**SUBDIVISION &  
PLANNED UNIT DEVELOPMENT  
STAFF REPORT**

**Date: December 21, 2017**

<b><u>APPLICANT NAME</u></b>	Dewberry/ Preble-Rish
<b><u>SUBDIVISION NAME</u></b>	Longleaf Gates Subdivision, Phase 1, Resubdivision of Lots 120-137
<b><u>DEVELOPMENT NAME</u></b>	Longleaf Gates Subdivision, Phase 1, Resubdivision of Lots 120-137
<b><u>LOCATION</u></b>	Area bounded by Foxtail Drive, Lace Bark Drive and Whitebark Drive
<b><u>CITY COUNCIL DISTRICT</u></b>	District 6
<b><u>PRESENT ZONING</u></b>	R-2, Two-Family Residential District.
<b><u>AREA OF PROPERTY</u></b>	2.0 ± acres
<b><u>CONTEMPLATED USE</u></b>	Subdivision approval to create twelve (12) legal lots of record from eighteen (18) legal lots; and Planned Unit Development to amend a previously approved Planned Unit Development to allow a private street, gated subdivision, with reduced lot sizes, reduced front yard and side yard setbacks, and increased site coverage.
<b><u>TIME SCHEDULE FOR DEVELOPMENT</u></b>	Not specified.

# SITE PLAN

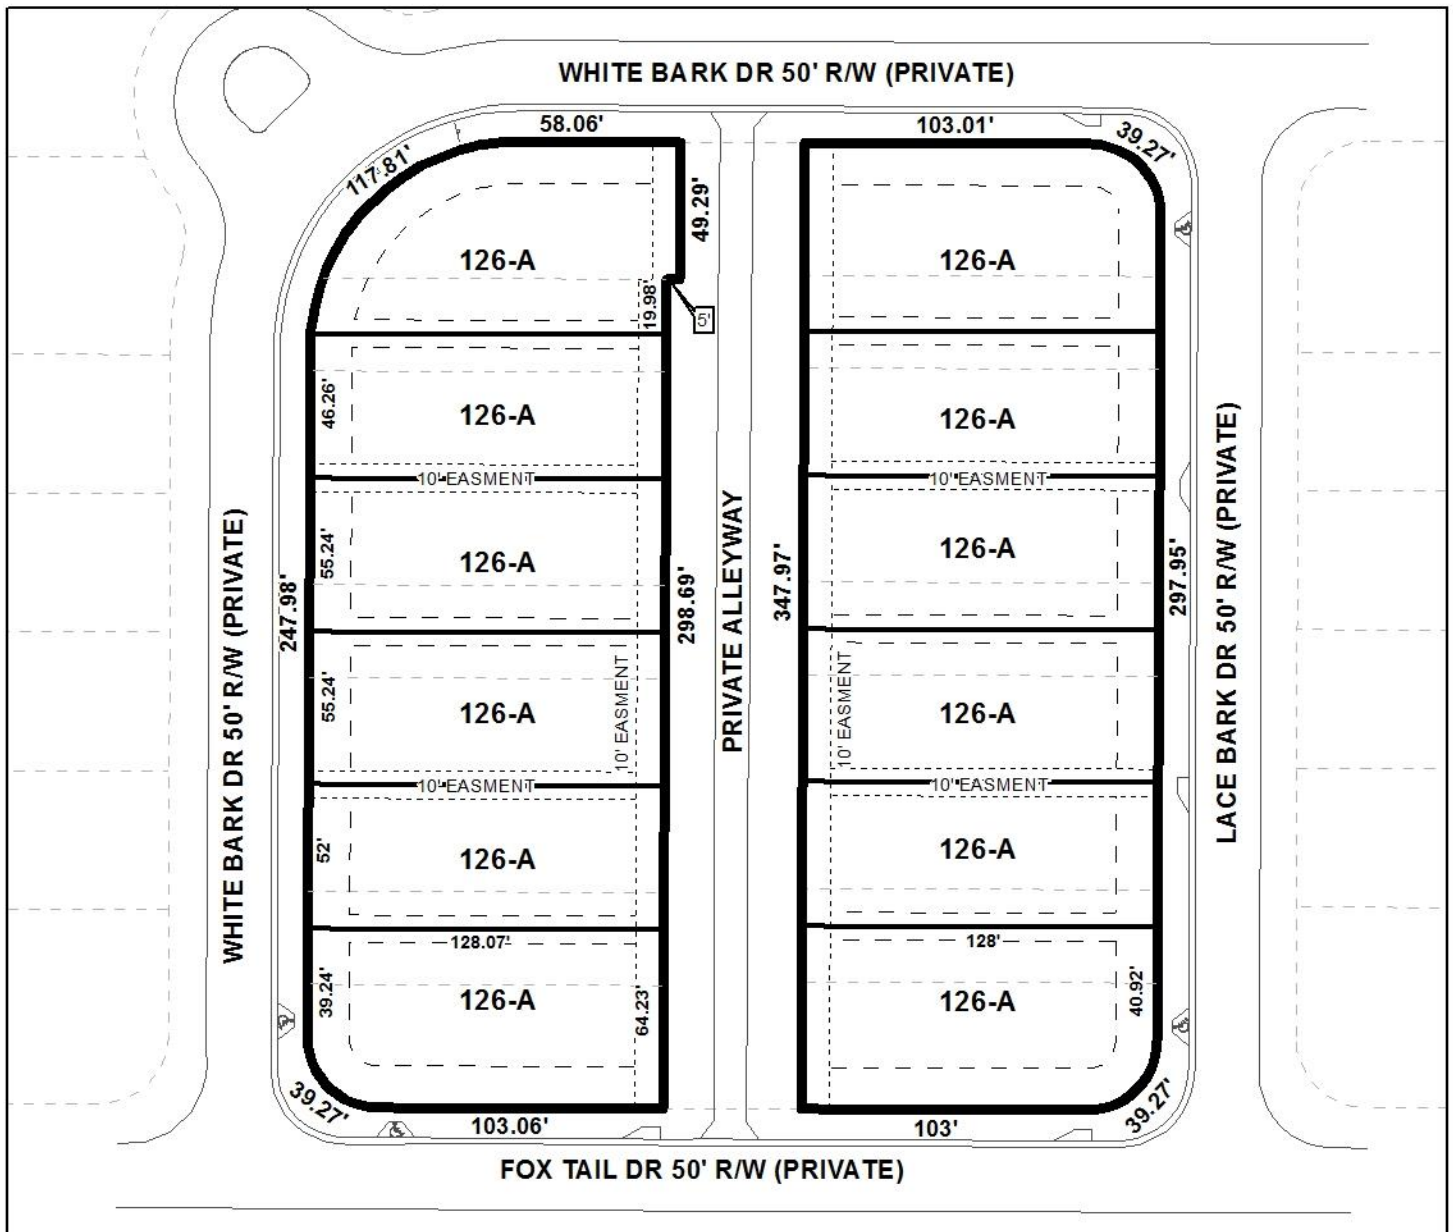
The preliminary plat illustrates minimum building setback lines for each lot, but does not label the lines with the setback. Instead, a chart is provided that gives information regarding the setback requirements which are proposed at follows:

The proposed site plan illustrates 12 lots bisected by an alley with a 50' right-of-way width. The proposed alley will run North and South and it will connect White Bark Drive to Fox Tail Drive, both of which are private streets.

It should be noted that there is a 10' easement along the alley. A note should be placed on the Final Plat stating that no structures shall be erected in any easement.

While the preliminary plat and PUD site plan provides information regarding reduced setbacks, there is no mention of site coverage requirements. If approved, the information regarding site coverage for the proposed lots should be provided on the Final Plat, and is limited to 35%.

HVAC condenser units and similar mechanical equipment must comply with section 64.4-D.11. of the Zoning Ordinance, and should be placed as a note on the PUD site plan.

As the development has common areas and private streets, a note should be placed on the Subdivision plat and Planned Unit Development site plan stating that maintenance of all common areas and private streets is the responsibility of the property owners.

- 1) Revision of the site plan to include site coverage information limited to 35% for the proposed lots;
- 2) Retention of 15' front yard setback, 10' rear yard setback, 5' side yard setback and 15' side street side yard setback;

- 3) Placement of a note on the Final Plat stating each lot is limited to one curb cut to the alley, with any changes to be approved by Traffic Engineering and conform to AASHTO standards;

- 4) Placement of a note stating that HVAC condenser units and similar mechanical equipment will comply with Section 64-4.D.11. of the Zoning Ordinance;

- 5) Placement of a note stating that no structures shall be erected in any easement;
- 6) Placement of a note stating that the maintenance of all common areas and private streets is the responsibility of the property owners;
